Conflict #1

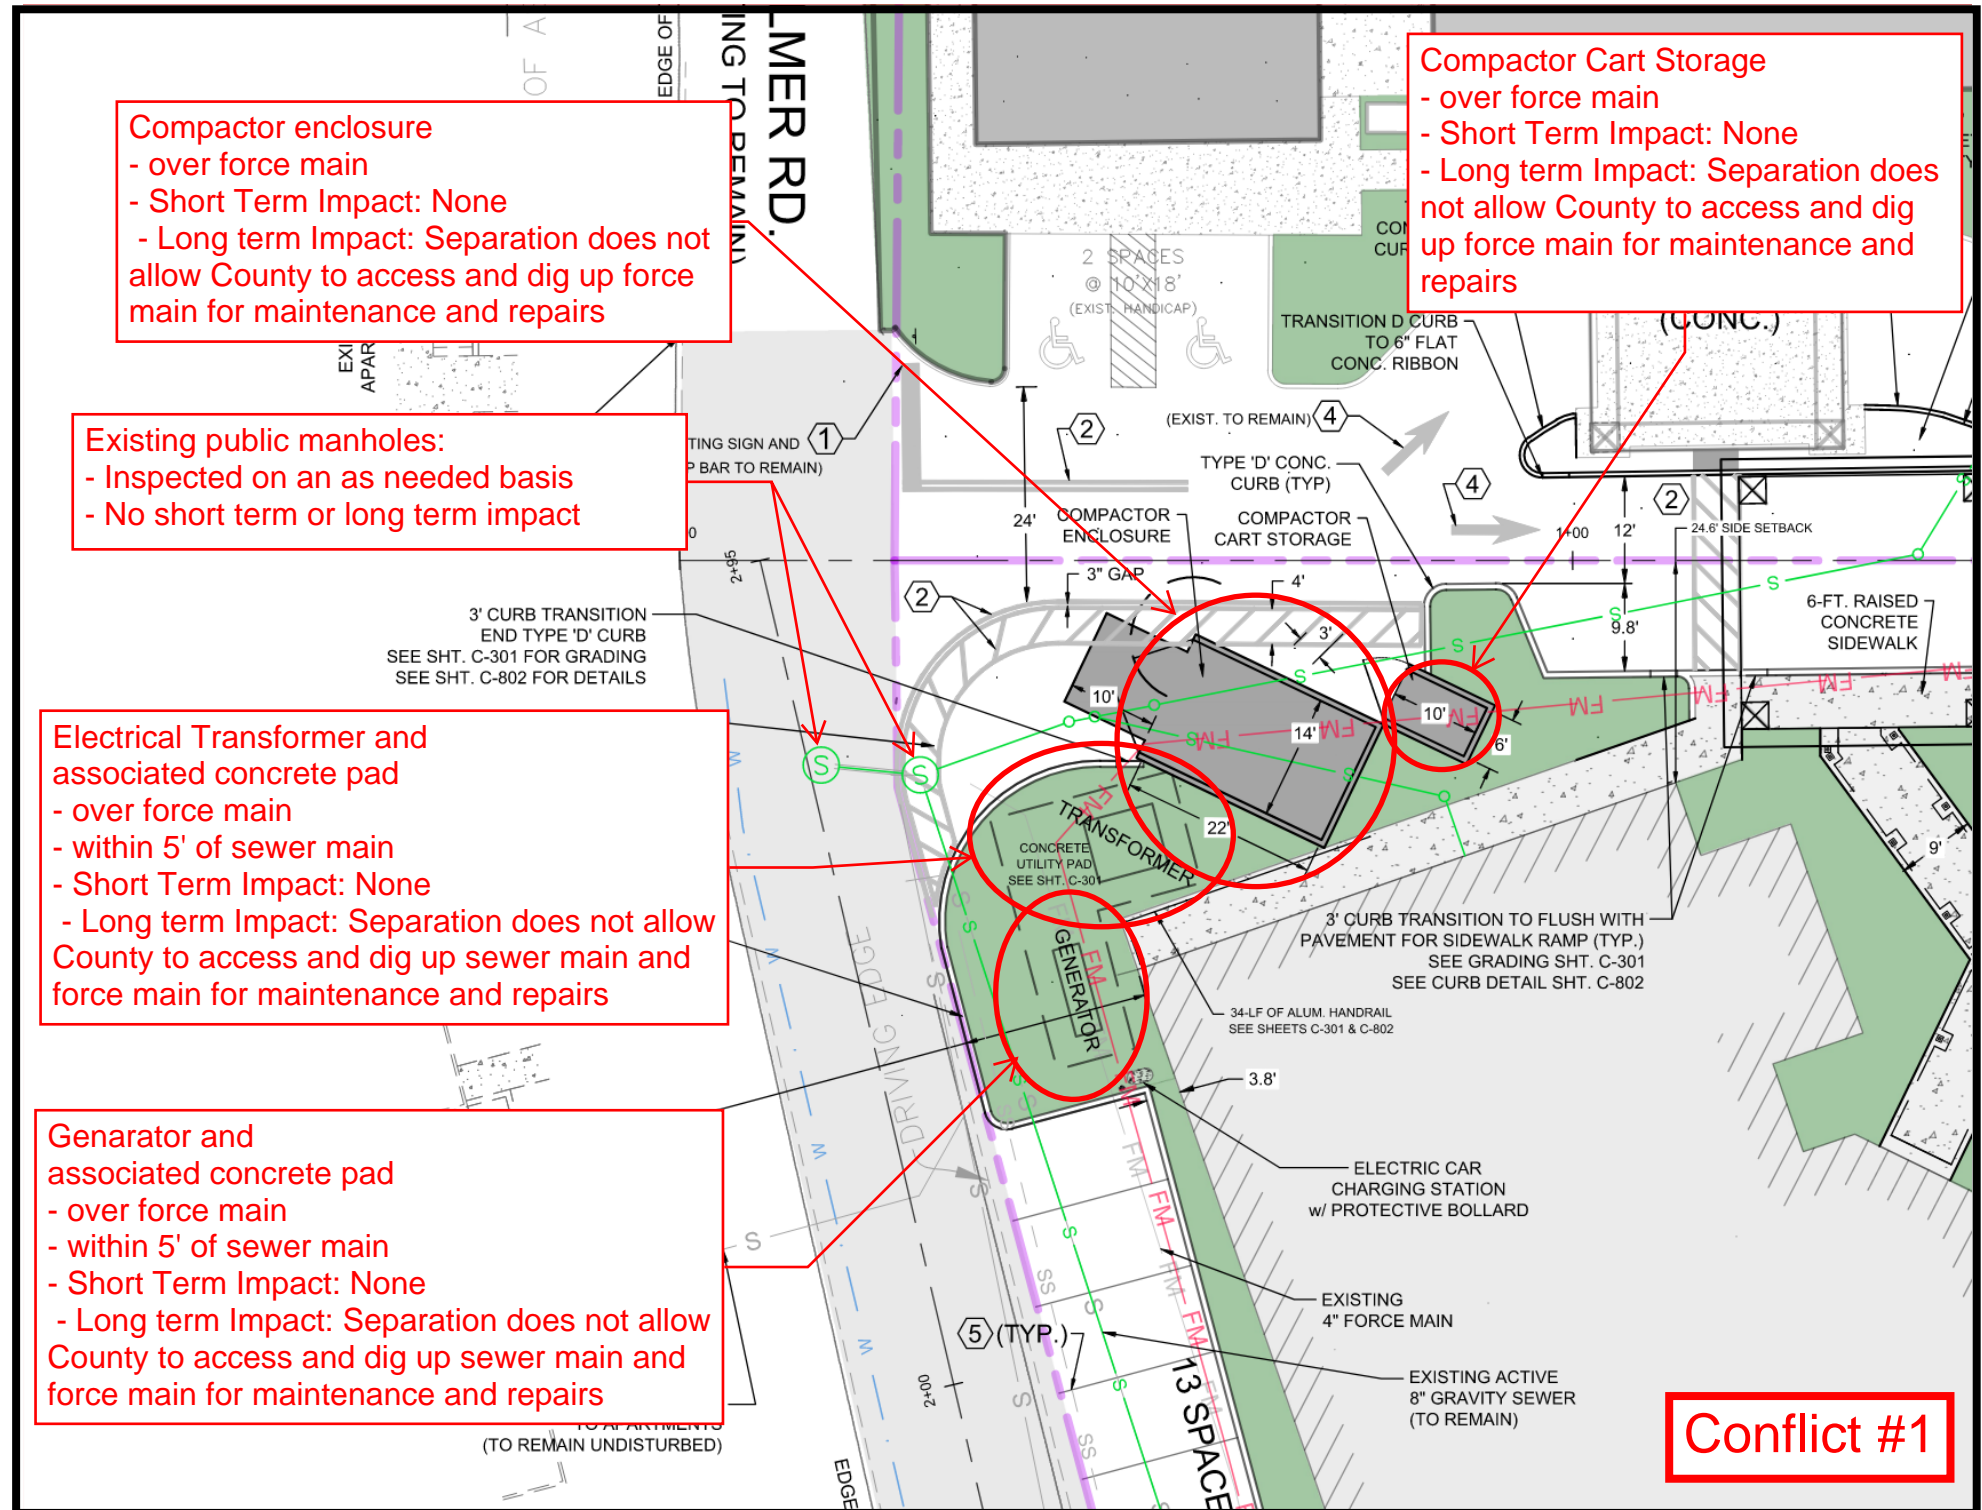
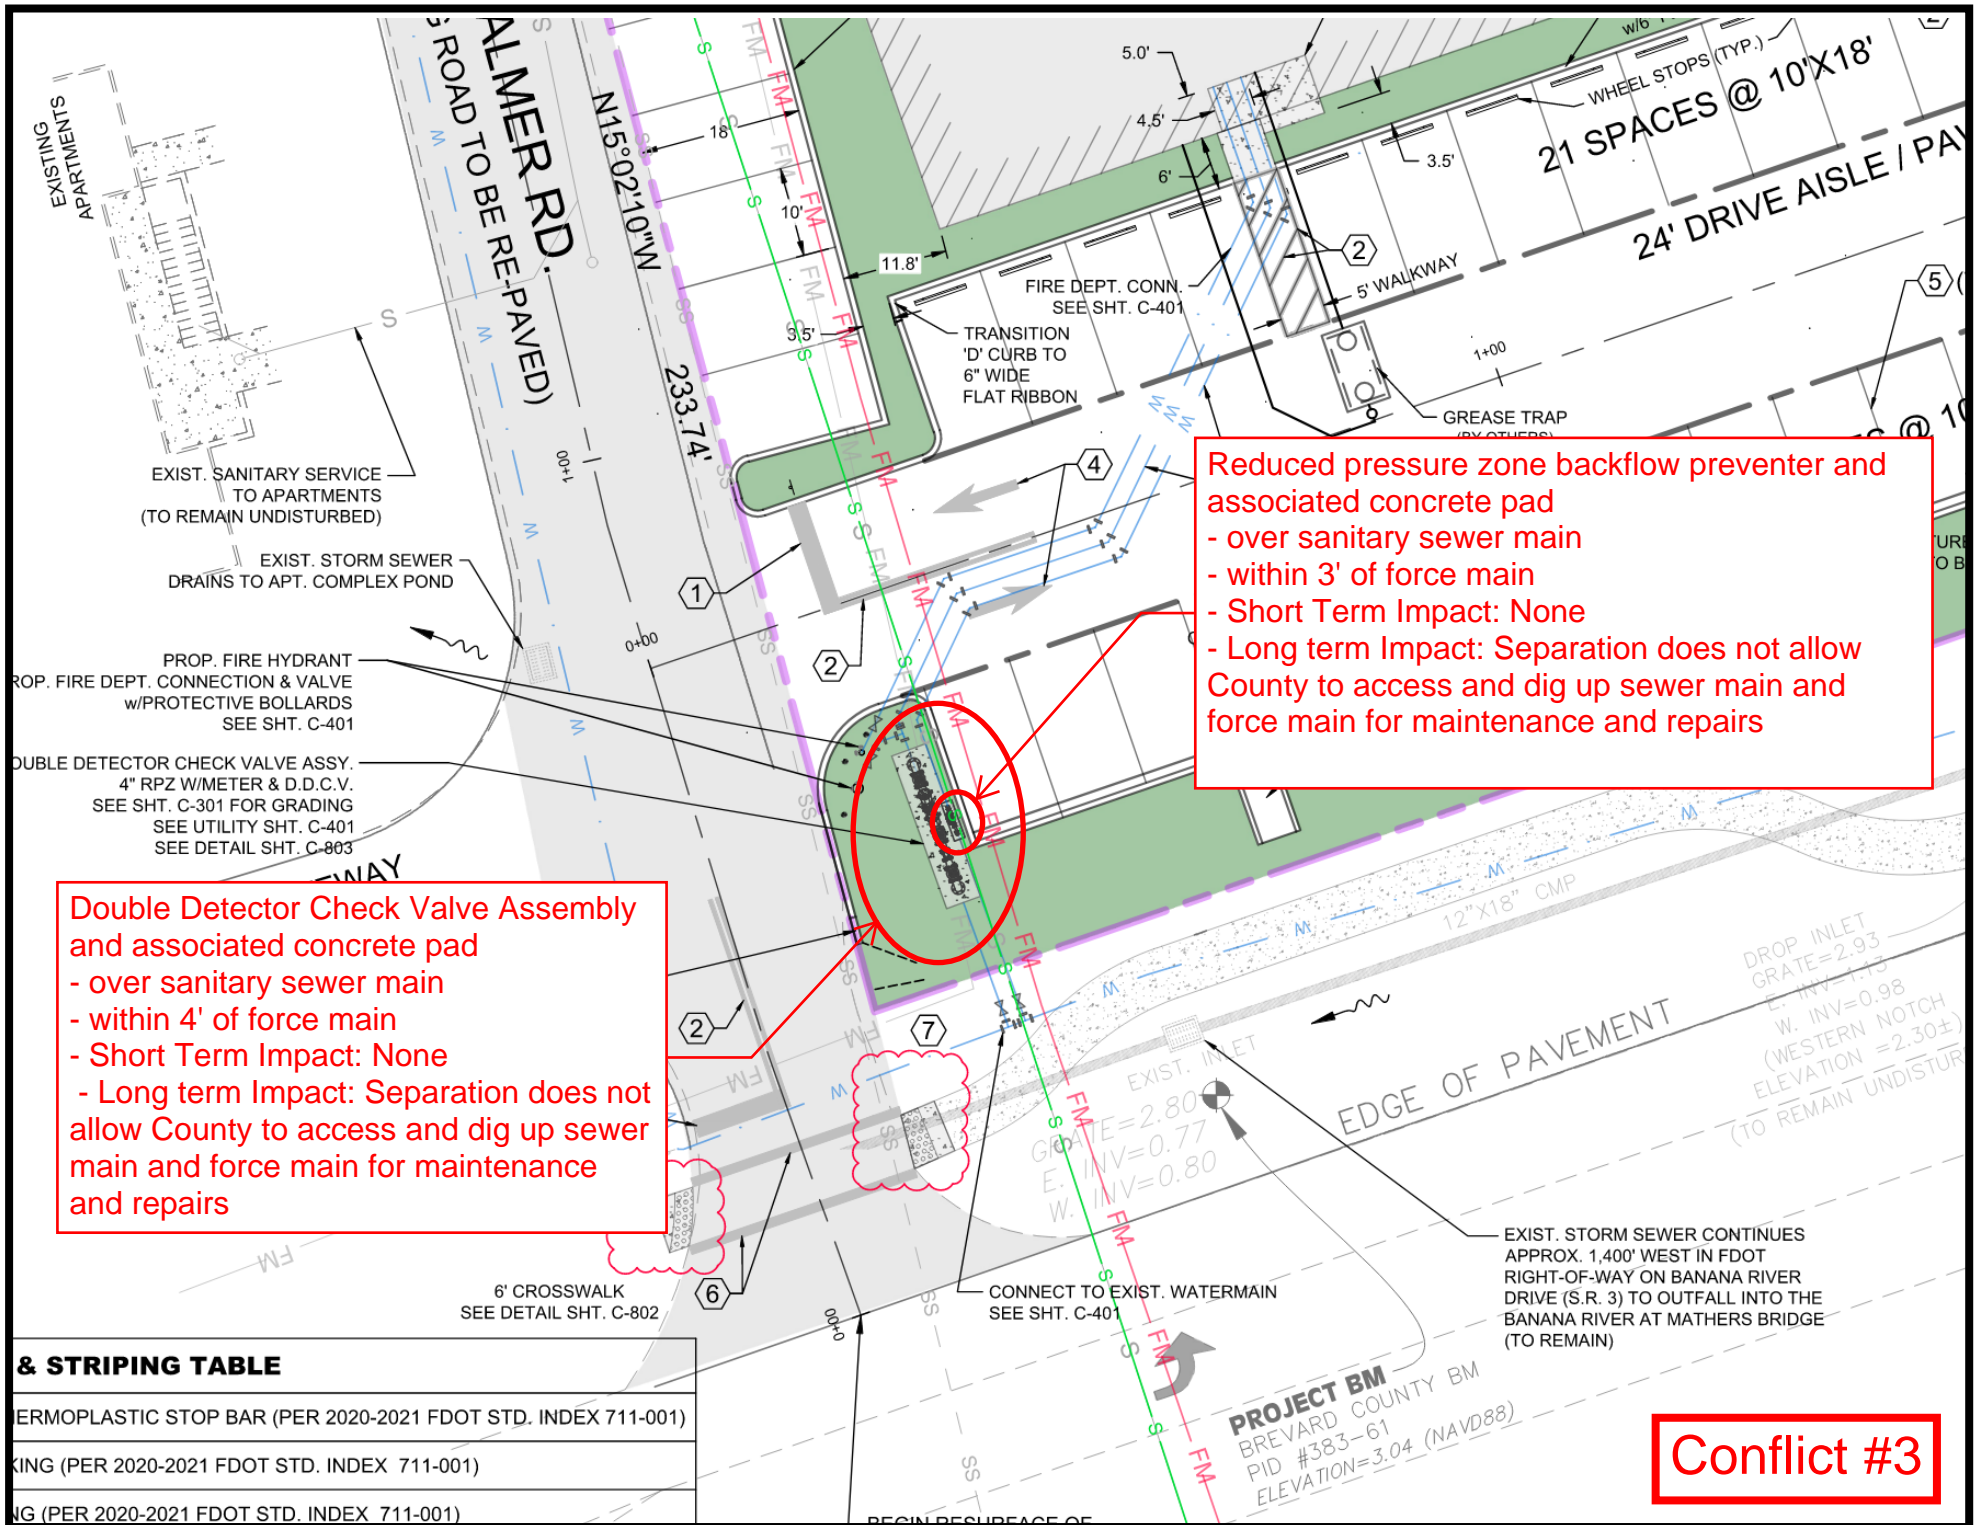
Compactor enclosure

- over force main
- Short Term Impact: None
- Long term Impact: Separation does not allow County to access and dig up force main for maintenance and repairs

Compactor Cart Storage

- over force main
- Short Term Impact: None
- Long term Impact: Separation does not allow County to access and dig up force main for maintenance and repairs

Electrical Transformer and associated concrete pad

- over force main
- within 5' of sewer main
- Short Term Impact: None
- Long term Impact: Separation does not allow County to access and dig up sewer main and force main for maintenance and repairs

Generator and associated concrete pad

- over force main
- within 5' of sewer main
- Short Term Impact: None
- Long term Impact: Separation does not allow County to access and dig up sewer main and force main for maintenance and repairs
